RE: OPUC Docket LC 79 - Comments on Final Staff Report 3/30/2023

I would take issue with the recommendation to acknowledge the \$10-15 million replacement of the PDX LNG Cold Box (Action Item #2).

# Heat pump sales in U.S. surged past gas furnaces in 2022

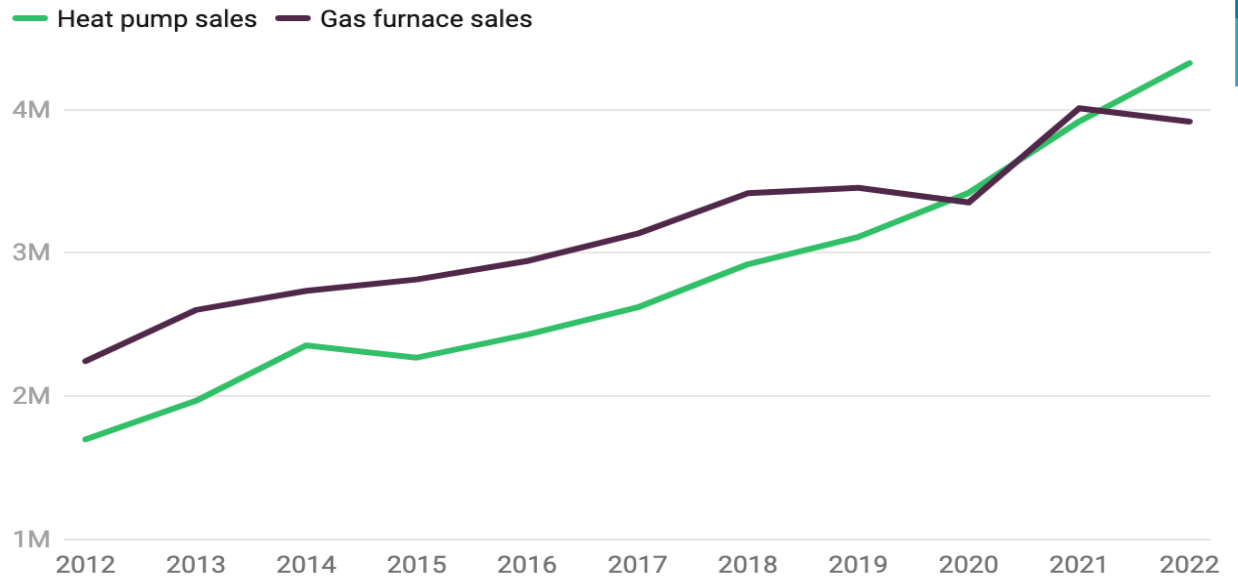
Gas furnaces have a lifespan of somewhere around 20 years, which means that approximately 5% of all furnaces will need replacement annually. Nationally, electric heat pump sales in 2022 exceeded gas furnace sales (see image below). If just half of gas furnaces in the area served by PDX LNG were replaced with heat pumps as they reached the end of their lives, within about six years the PDX LNG would no longer be necessary, as at least 15% of natural gas furnaces would have been removed. It is quite possible that this transition may happen considerably more quickly. Once again, it makes sense to wait until we are able to observe the rate of electrification of home heating over the next couple of years before investing in new gas infrastructure.
